SERVICE BULLETIN

SB No. 107 Issue No. 1

TITLE INSPECTION OF PILOTS MIXTURE LEVER

T67M260 and T67M260-T3A.

FIG 1
SHOWING POSITION OF GROOVE

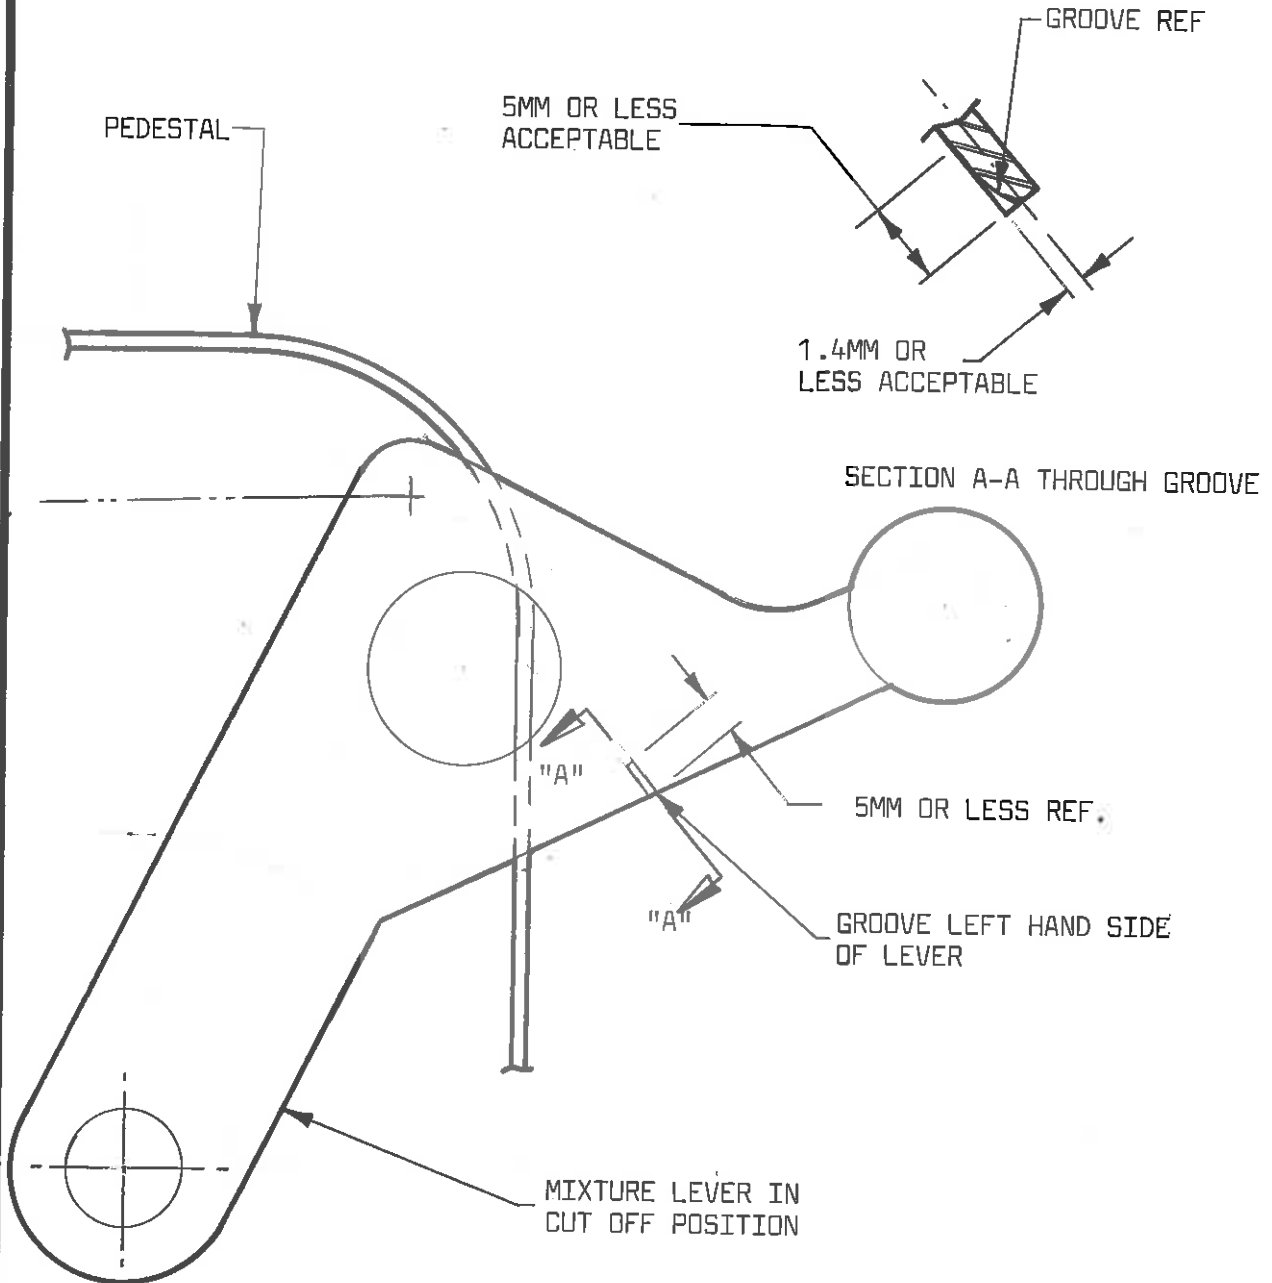
When operating the mixture lever from the full rich position to the lean position, it was noticed that mixture lever could be pulled past its gate toward the cut off position.

Upon investigation it was noted that the aluminium alloy mixture lever had a groove worn into it, having been caused by the pedestal gate.

1. Visually inspect mixture lever for a groove. Ref Fig 1 for position.
2.
 - i) If a groove is absent, monitor every 50 flying hours with reference to Action 2ii).
 - ii) If there is a groove and it is 5mm or less in length, on the side of the lever and/or the groove is to a depth of half thickness of the lever (1.4mm) or less - ref Fig. 1, Section A-A - the lever is to be changed at next 150 flying hours, either with a new existing aluminium lever T67G-50-553 or Mod M722, steel lever, to be invoked.

- iii) If there is a groove and its length is greater than 5mm and/or its depth is greater than half the levers width, then lever is to be changed at next 50 flying hours, either with a new existing aluminium lever T67G-50-553 or Mod M722, steel lever, to be invoked.

If new aluminium lever T67G-50-553 is fitted, then re-inspect at next 150 flying hours, ref actions 2 i) and ii).

3. Annotate aircraft log book "SB 107 complied with" on initial inspection and at each subsequent inspection, ref Actions until Mod M722 invoked.
